ALLISON CREEK HYDROELECTRIC PROJECT

This is the response to the above referenced letter regarding Project No. 7383 license application deficiencies.

This responds to your request of December 20, 1984 for Fish and Wildlife comments on the referenced document. These comments should be used to revise the draft prior to forwarding the application for license to the Federal Energy Regulatory Commission (FERC). See our previous correspondence for the Lake Creek Project (FERC 7382) dated November 23, 1984 (attached). These detailed comments apply to the Exhibit E for Allison Creek.

ALLISON CREEK
FIGURE 1
SALMONID LIFE-STAGE TIMINGS

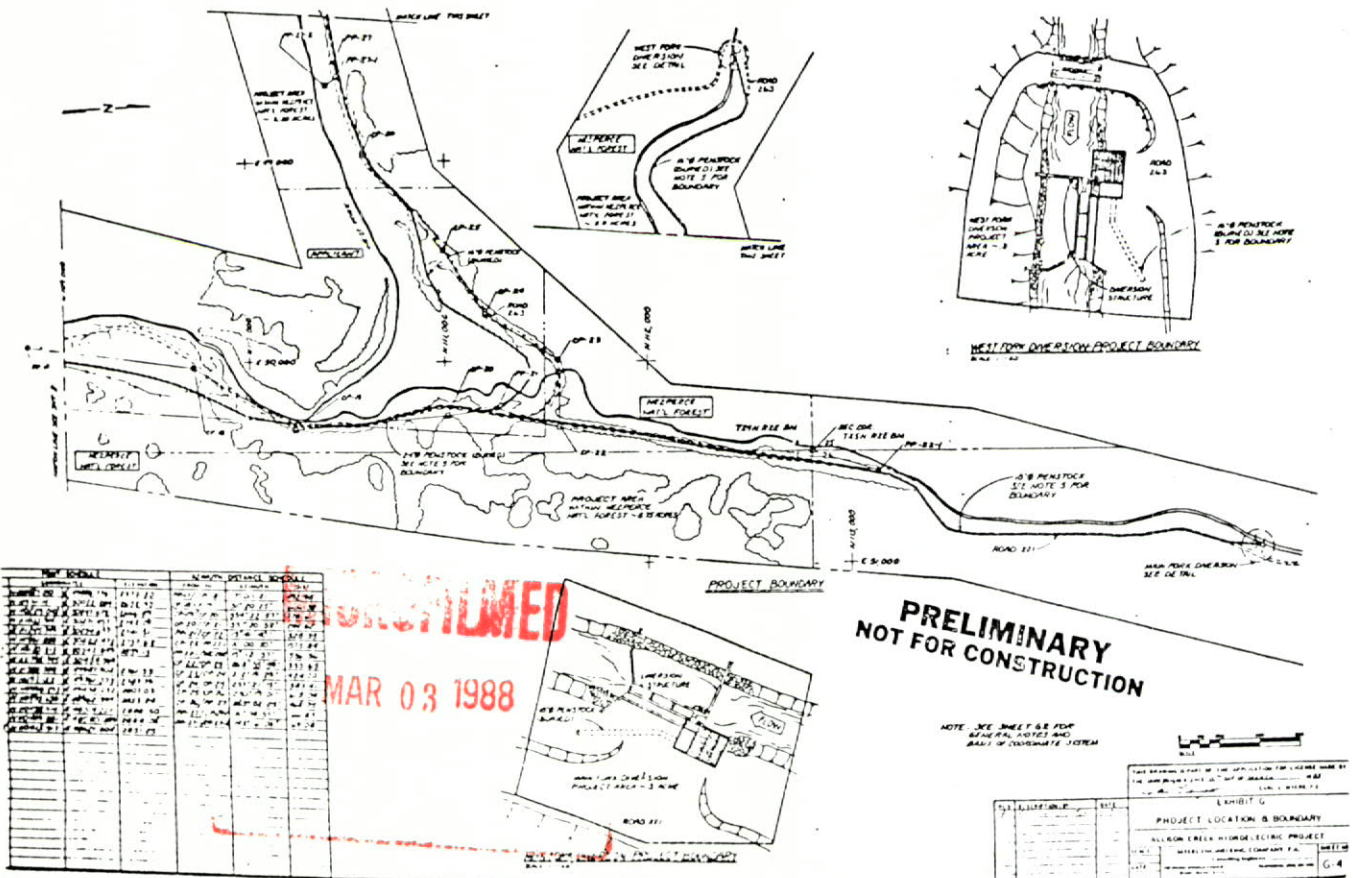
Figure 1 does not adequately or accurately reflect life stage timing of salmonids in the project area. See our previous correspondence for the Lake Creek project (FERC 7382) for a detailed recommendation concerning this figure.

Construction would have to be timed to miss spawning and incubation periods based on our letter of November 23, 1984 for the Lake Creek Project, not on your Figure 1. New instream construction, construction at stream crossings, and construction adjacent to the stream will add to the suspended and bed loads of Allison Creek. This would have adverse effects on the fishery and other aquatic resources and on habitat of Allison Creek.

SCALE	AYERS ENGINEERING COMPANY, P.A.	SHEET NO.
N.T.S.	Consulting Engineers	F-2
DATE	THUNDERBOLT ROAD	
	EDMUND, ARIZONA

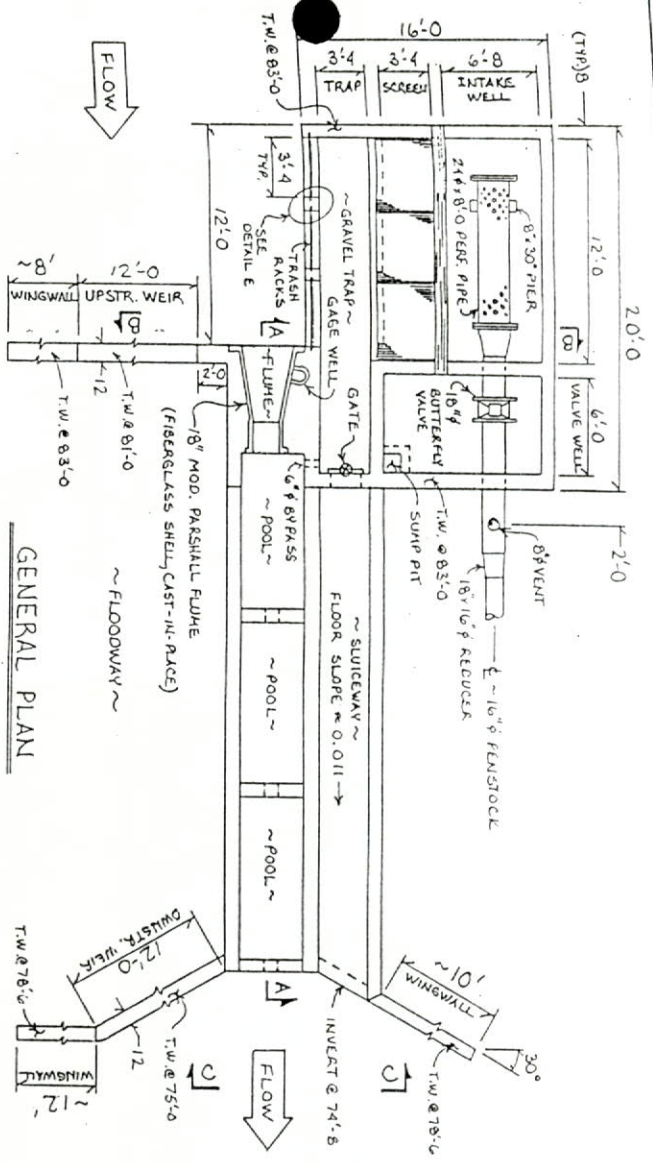
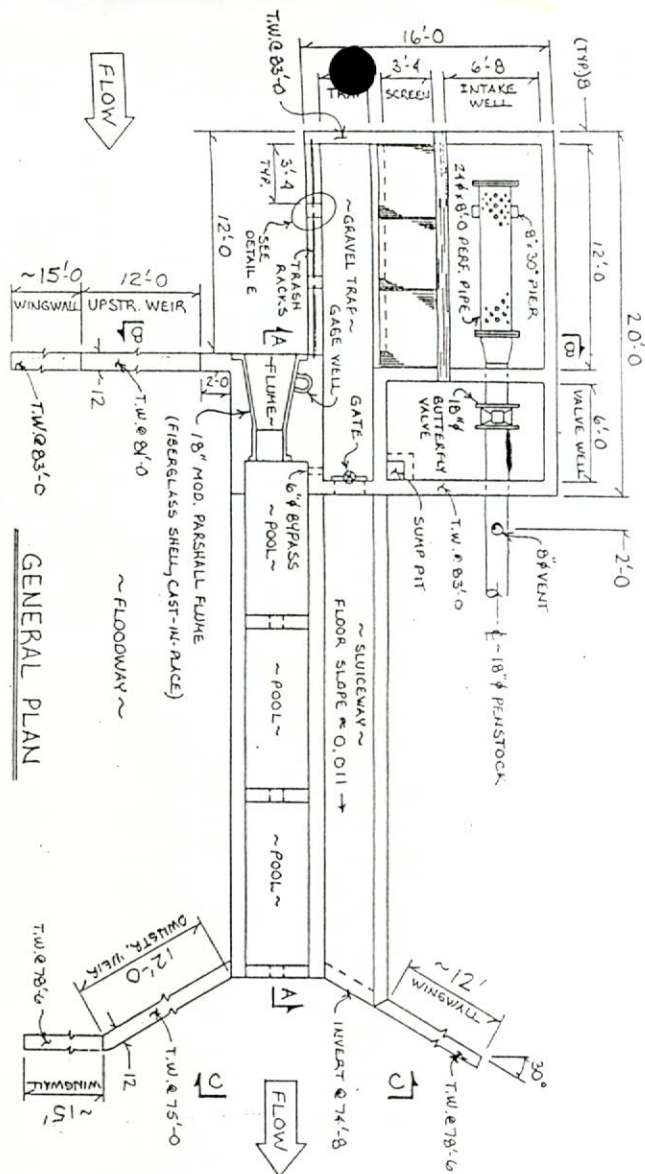
- (1) Revise the Exhibit F-2, F-3, and F-5 drawings by showing the vertical control datum for the given elevations of the diversion and powerhouse structures.

Another concern associated with flushing flows is the diversion structure. Cross sections of the structures (see Exhibit F, Sheet F-2 of the license application) shows that they consist of a Parshall flume, a gravel trap, and a sediment trap.

Revised Exhibit F-2, F-3, and F-5 drawings, showing the vertical control datum for the elevations of the diversion and powerhouse structures, has been included as Appendix II. Please note that drawing F-5 did show an elevation of 1905.6 in the license application.

SCALE	MAYERS ENGINEERING COMPANY, P.A.	SHEET NO.
DRAWN BY	Consulting Engineers	
CHECKED BY	MEMPHIS, TENN 38101	
DATE	27-7-65	F-3

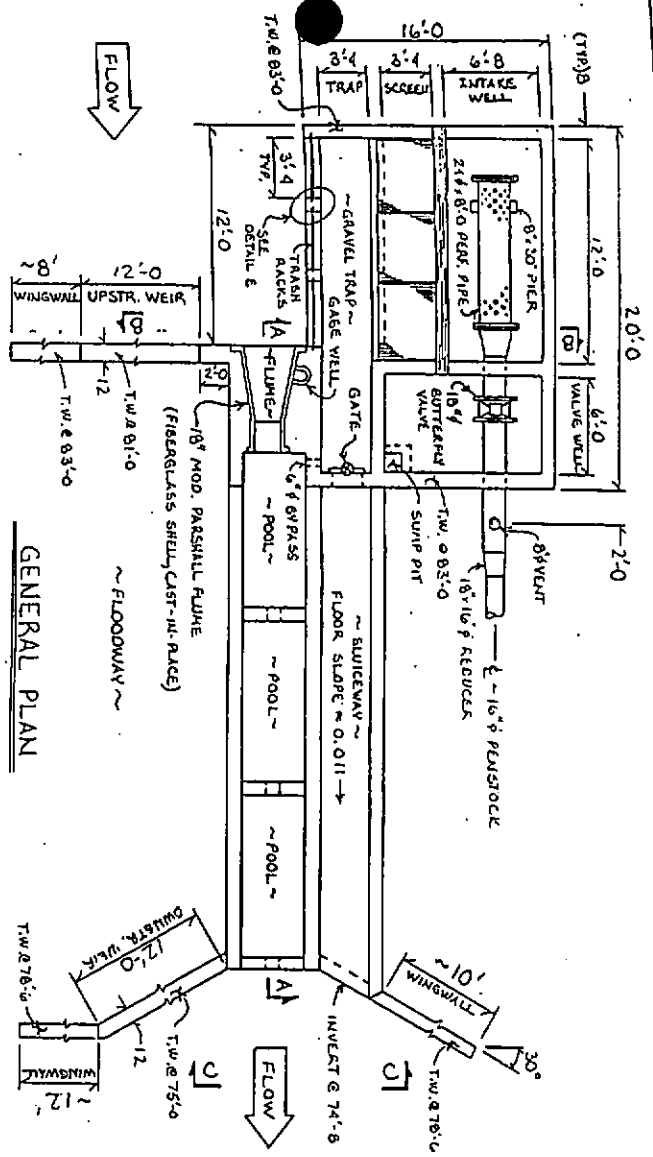
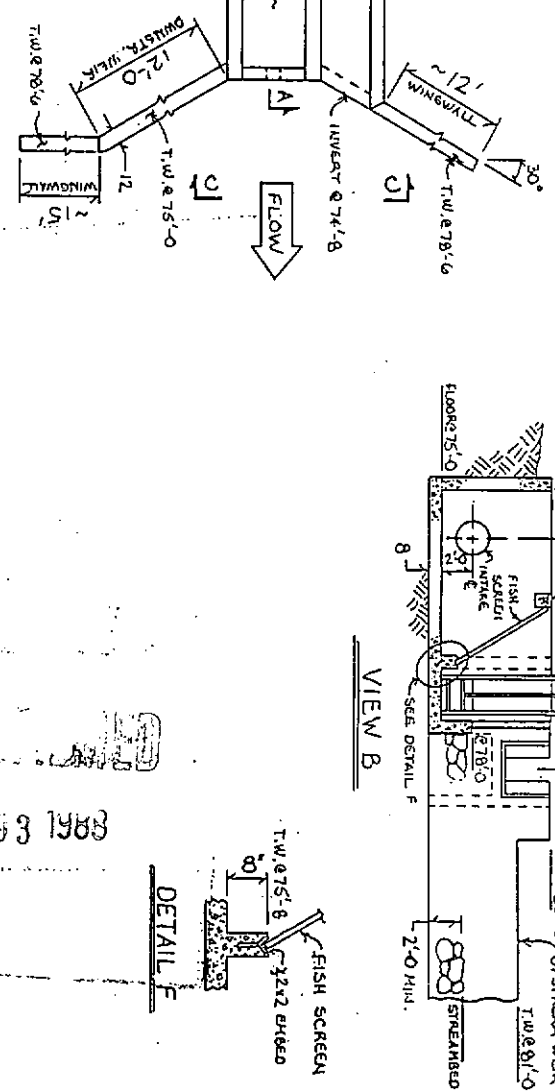
- (4) Provide functional design drawings of proposed fish passage and protection facilities at the diversion structures, to include comments on the drawings from the NMFS, USFWS, and the Idaho Department of Fish & Game (IDFG). If agency recommendations are not included in the design of these facilities, Applicant must explain why they were not considered.

Functional design drawings of proposed fish passage and protection facilities at the diversion structures were provided in the Application for License, Exhibit F-2 and F-3 drawings. Both drawings have been revised to include the vertical control datum and are included in Appendix III of this document.
